**PLANNED UNIT DEVELOPMENT
& SUBDIVISION STAFF REPORT****Date: January 17, 2008****DEVELOPMENT NAME**

Grande Oaks at Hillcrest Subdivision

LOCATION2709 Hillcrest Road
(East side of Hillcrest Road, 340'+ North of Shady Lane)**CITY COUNCIL
DISTRICT**

Planned Unit Development Approval to allow a gated private street single-family residential subdivision, and Subdivision approval to create 19 lots.

SITE PLAN

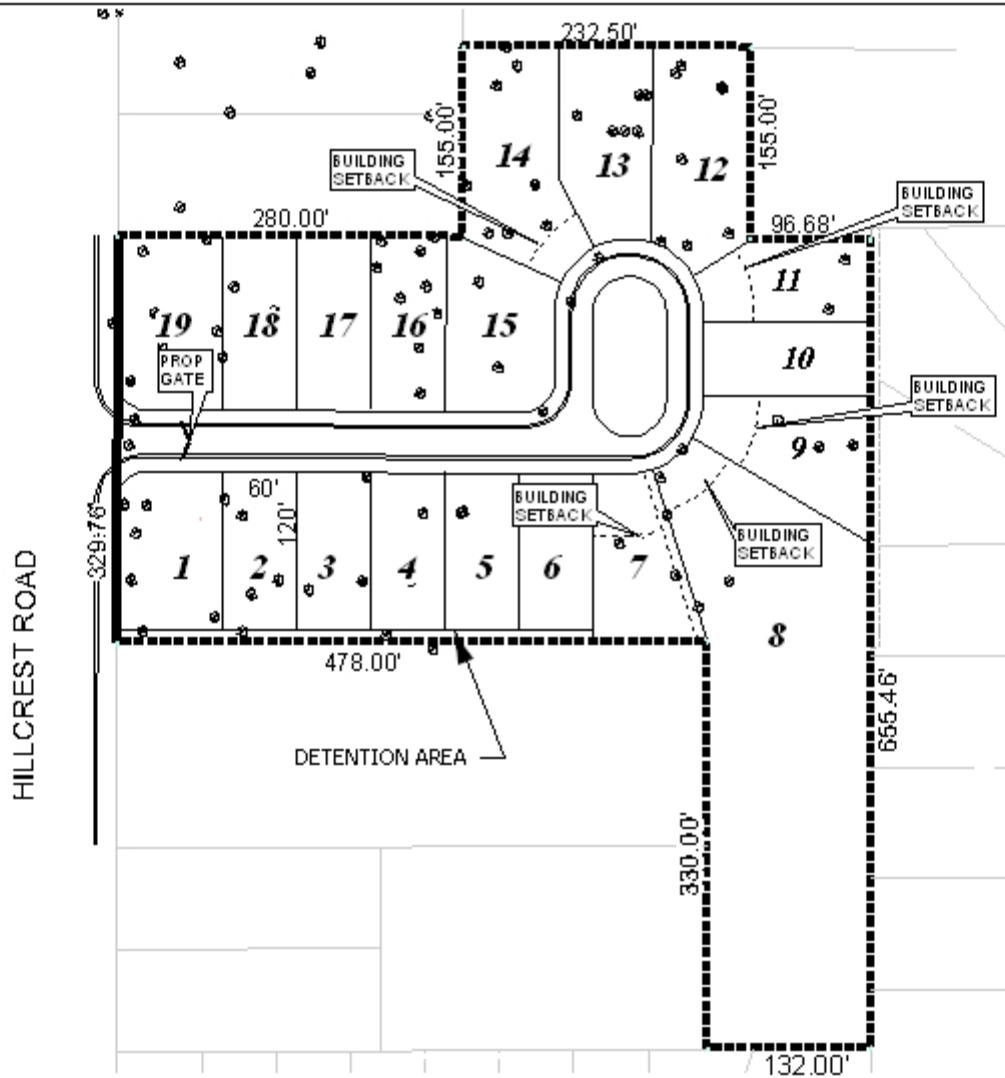
Need to show drainage easement from detention area to Weddington Court. Analysis of the receiving system will be required to determine if the existing system has the capacity to receive the additional flow. Must comply with all storm water and flood control ordinances. Any work performed in the right of way will require a right of way permit.

The proposed private street will be a cul-de-sac, with what appears to be a large common area contained within the cul-de-sac. While the overall dimensions of the cul-de-sac appear to comply with the 2003 International Fire Code, as adopted by the City of Mobile, the apparent one-way circulation around the common area may not meet the minimum pavement width requirements, specifically where fire hydrants occur. The site plan and plat should be revised to ensure compliance with any requirements of the Mobile Fire-Rescue Department and Traffic Engineering.

The unlabeled area in the cul-de-sac should be labeled as common area, and a note should be placed on the site plan and plat stating that all common areas and the detention area are to be maintained by the property owners association.

All of the lots appear to meet the minimum dimensional requirements of the Subdivision Regulations, however, the minimum building setback line is not depicted for every lot. The site plan and plat should be revised to depict the minimum building setback line for each lot, where the lot is at least 60-feet in width. It should also be noted that there do not appear to be any requests by the applicant for reduced setbacks or increased site coverage, thus the standard requirements for R-1, Single-Family Residential districts will apply.

The revised site plan and plat depict 19 lots as before, but now shows the detention area as a narrow strip located behind Lots 1-6, along the southern property line. The revised plan labels the detention area as 7,680 square feet, however, measuring of the drawing indicates that it is in fact only half of the size claimed. Furthermore, the side lot-line dimensions are incorrect for the actual measured distance for the lots abutting the detention area. Finally, the area of Lot 8 should be rechecked, as it is the same as the previous application – even though the detention area is no longer located at the rear of Lot 8. It appears that even with these dimensional errors, the application will meet the minimum lot size and dimensional requirements of the Subdivision Regulations and the Zoning Ordinance.

The detention area should be fenced from all adjacent lots, including the existing residential property to the South of the site. Provisions for access and maintenance should be made regarding the design of the fence. Permits are required for any fencing, including that provided around the detention area. An access easement should be provided to the detention area from the street that is a part of the development so that access for maintenance is not from Hillcrest Road: the site plan and plat should be revised to depict the access easement.

- 1) Revision of the site plan and plat to correct all dimensional and lot area errors, ensuring that all lots are a minimum of 7,200 square feet, and the labeling of all lots with their size in square feet;

- 2) Depiction and labeling of the minimum building setback line from all street frontages for all lots, where the lot is a minimum of 60 feet in width;

- 4) Revision of the site plan and plat to depict and label an access easement from the street that is part of the development to the detention facility to allow maintenance;

- 5) Provision of a six-foot high wooden privacy fence around the entirety of the detention area (except within required street setbacks, where it shall not exceed three feet in height), with appropriate permits, and revision of the site plan to depict and label a fence;

- 1) Revision of the site plan and plat to correct all dimensional and lot area errors, ensuring that all lots are a minimum of 7,200 square feet, and the labeling of all lots with their size in square feet;

- 2) Depiction and labeling of the minimum building setback line from all street frontages for all lots, where the lot is a minimum of 60 feet in width;

- 4) Revision of the site plan and plat to depict and label an access easement from the street that is part of the development to the detention facility to allow maintenance;
